AFTS 629/11/14/RPRT-001

**CRITICAL REVIEW OF THE KALKARA SYSTEM
SAFETY AND HAZARD ANALYSIS**

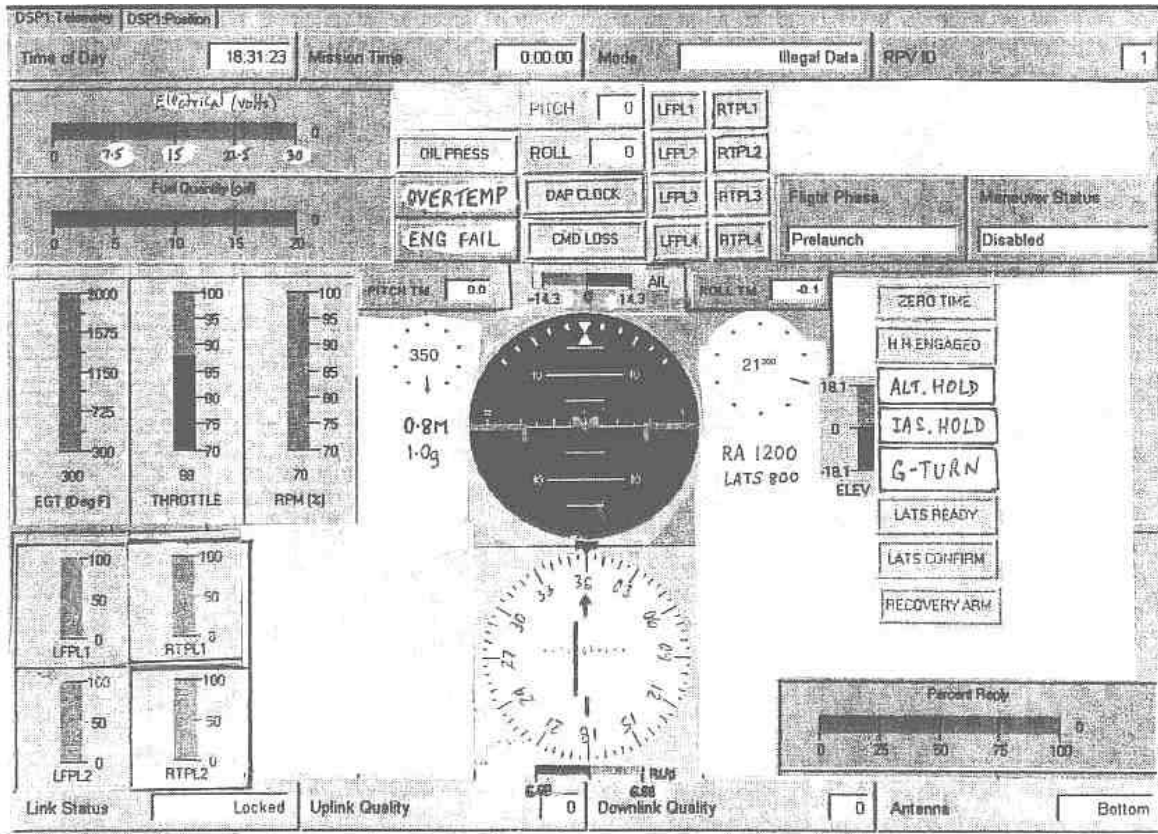
e. 23.1321(d): requires the 'standard-T' presentation of flight instruments, with which the Primary Display does not presently comply; the present display is illustrated in the following diagram.

8.10.3 In order to comply with a 23.1321(d) presentation requirement, the basic flight parameters of airspeed and altitude need to be moved to the left and right positions, adjacent to the ADI. The following example of a compliant presentation follows the contemporary standard for HUD displays, namely counter-pointer indicators for airspeed and altitude, with Mach Number and load factor alphanumerically indicated, below the airspeed indicator, and radar altitude and LATS datum radar altitude, indicated alphanumerically, below the altimeter indicator. This standard presentation declutters the flight instrument section of the Controller's Primary Display.

8.10.4 The navigation instrument presentation requirement is satisfied by the transformation of the compass indicator to an HSI. The engine and related instruments (fuel and busbar voltage indicators) are grouped together. Although the engine instruments are located in the non-standard position to the left of the airspeed/Mach indicators, being adjacent to the airspeed indicator maximises sensory perception of the power/performance relationship; engine OVERTEMP and ENGINE FAILURE annunciators have been added to the CAP, and normal autoflight system status annunciators (coloured green, as opposed to the two emergency conditions, LOC and loss of DAP clock, coloured red) grouped alongside the primary flight display section of the Display.

8.10.5 In the design of the annunciators, the contemporary 'quiet and dark' standard of aircraft design should be applied, namely that the annunciators remain unlit until activated ON by a status or condition. The Percent Reply indicator has been grouped with the UPLINK and DOWNLINK status indicators, along the bottom of the Display.

8.10.6 The aileron, elevator and rudder deflection indicators have been re-positioned, so that their sense of motion corresponds to the associated response of the aircraft.
